MECKLENBURG COUNTY
DEPARTMENT OF ENVIRONMENTAL HEALTH

APPLICATION FOR SOIL INVESTIGATION

Re: Property located at Cabarrus Road

SITE EVALUATION

**See Diagram on Back (includes: soil areas, property lines, roads, streams, gullies, wet areas, fill areas, wells, water bodies, slopes)

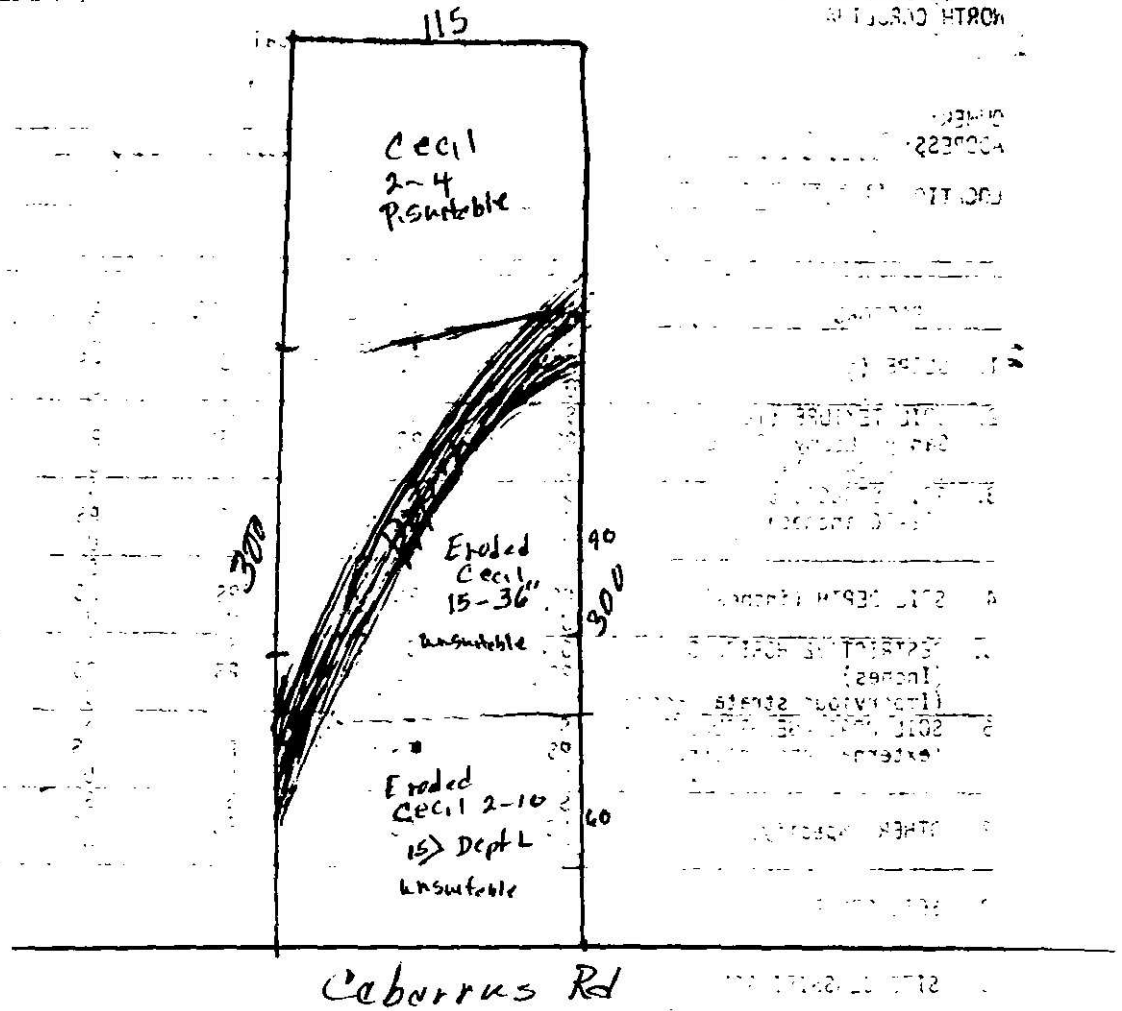
FACTORS	AREA 1	AREA 2	AREA 3	AREA 4
1. SLOPE (%)	(PS) 2-0	(PS) 2-4	PS	PS
2. SOIL TEXTURE (12-36 inches) Sandy, Loamy, Clayey (Note 2-1 Clay)	(PS) Clayey	(PS) Clayey	PS	PS
3. SOIL STRUCTURE (12-36 inches)	(PS) Blocky	(PS) Blocky	PS	PS
4. SOIL DEPTH (inches)	(PS) 12-36"	(PS) 45"	PS	PS
5. RESTRICTIVE HORIZONS (Inches) (Impervious strata, Rock)	(PS) None	(PS) None	PS	PS
6. SOIL DRAINAGE/GROUNDWATER (external and internal)	(PS) Adequate	(PS) Adequate	PS	PS
7. OTHER (Specify) Restrictive Area	(PS)	PS	PS	PS
8. SOIL GROUP	IVa	IIa		
9. SITE CLASSIFICATION	Unsuited	Suitable		
10. SOIL SERIES	Eroded Cecil	Cecil

115
Cecil
2-4
Pasturable
300
Eroded
Cecil
15-36"
Unsuitable
90
40
Eroded
Cecil 2-10
15> Depth
Unsuitable
60
Cabarrus Rd
